SERVICE BULLETIN

Beechcraft

TITLE: FLIGHT CONTROLS- RUDDER CABLE PULLEY BRACKET INSPECTION/REPAIR

Figure 1

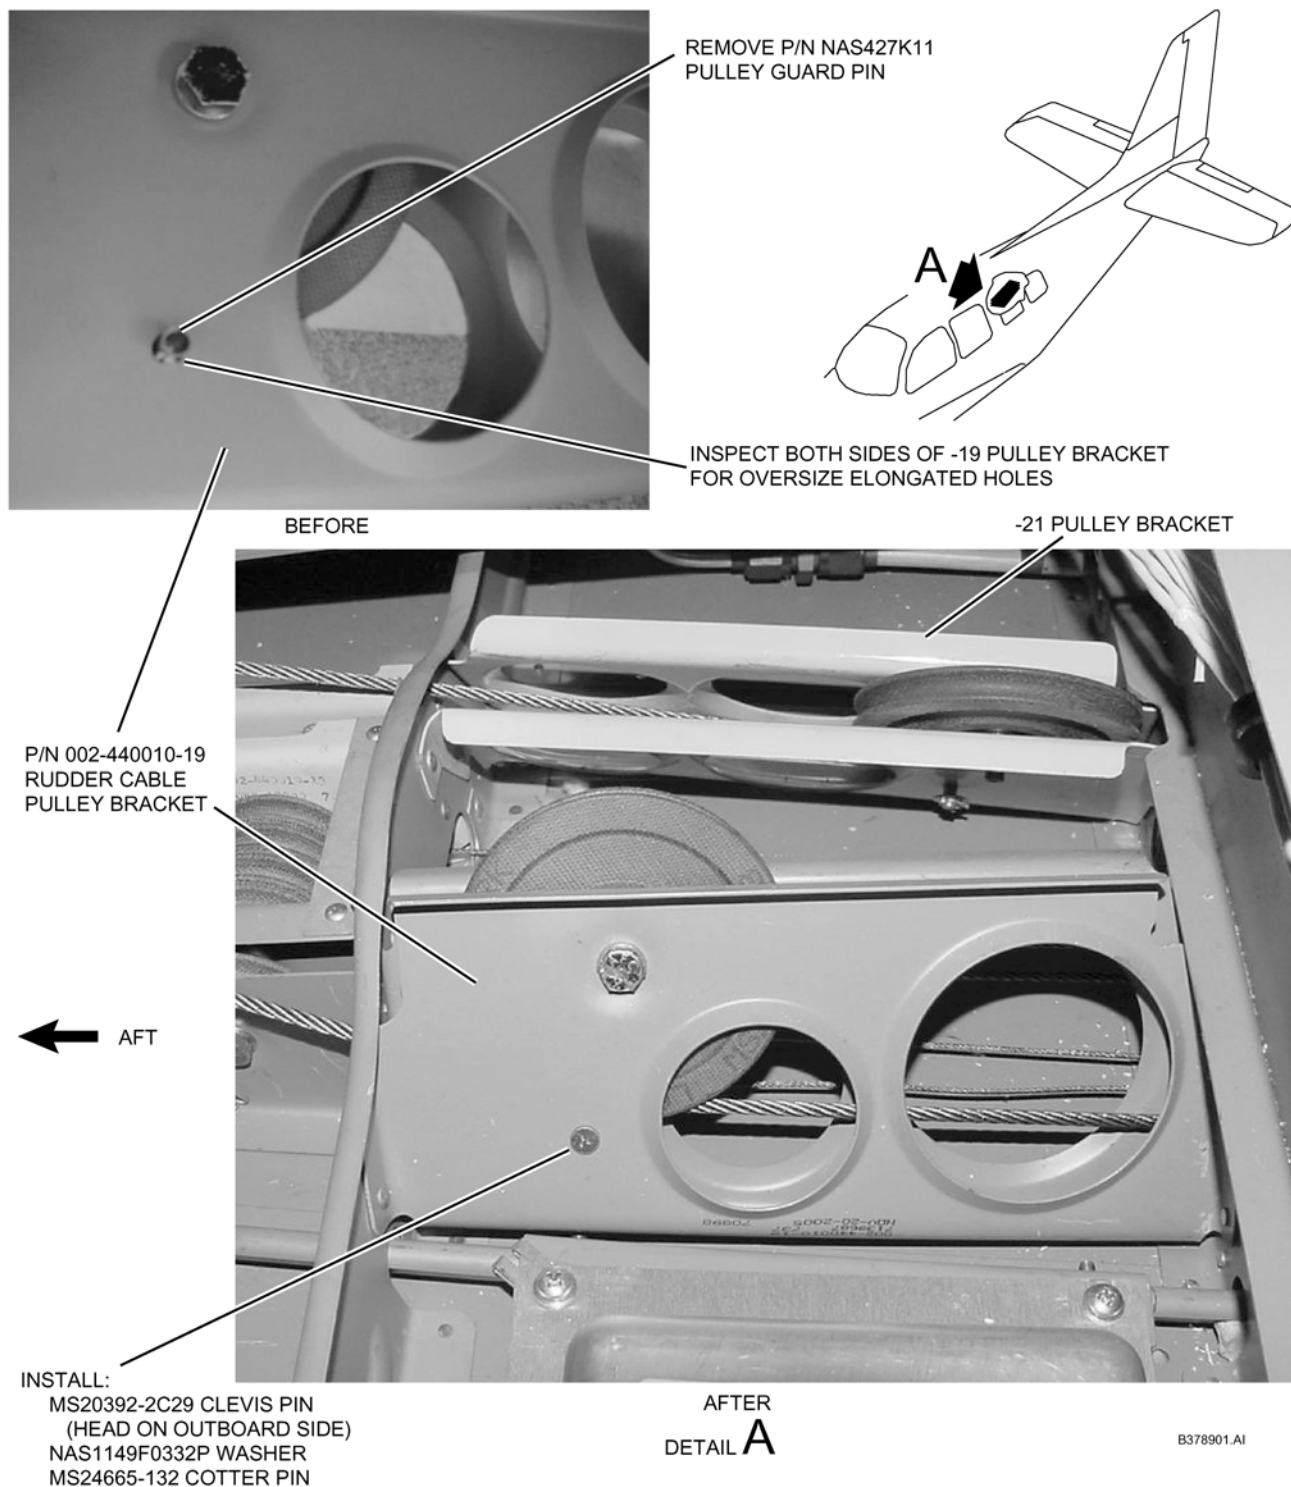
This Service Bulletin is being issued to inspect for P/N 002-440010-19 rudder cable pulley bracket that may have an elongated, misdrilled hole. An elongated hole may allow the pulley guard pin to shift in position and possibly cause inadequate cable guarding. During control system maintenance, inadequate cable guarding could allow displacement of the control cables.

The P/N 002-440010-19 pulley bracket is inspected for damage in the form of elongated holes from improper drilling. If elongated holes are found, replace the existing P/N NAS427K11 pulley guard pin with a P/N MS20392-2C29 clevis pin, NAS1149F0332P washer and MS24665-132 cotter pin. Verify the rudder control cable is routed correctly under the pin.

- (3) Between F.S. 151.00 and F.S. 179.00, locate the area where the suspect pulley guard pin holes are in the P/N 002-440010-19 rudder cable pulley bracket. The P/N 002-440010-19 rudder cable pulley bracket is canted inboard. Refer to Figure 1.

- (4) Inspect the existing holes in both sides of P/N 002-440010-19 pulley bracket for the P/N NAS427K11 pulley guard pin for an elongated hole or misdrilling condition. If the holes do not exhibit any evidence of elongation or misdrilling, proceed to step (6). If the holes show evidence of elongation/misdrilling, proceed to step (5).

- (5) Replace the existing P/N NAS427K11 pulley guard pin with an MS20392-2C29 clevis pin, NAS1149F0332P washer and MS24665-132 cotter pin. Refer to Figure 1.

- (6) Inspect the rudder control cable for condition and verify it is routed correctly under the pulley guard pin or clevis pin. Refer to Chapters 20 and 27 of the BEEHCRAFT Bonanza Series Maintenance Manual or Section 4 of the BEEHCRAFT Baron 55 and 58 Shop Manual for control cable rigging or replacement criteria.
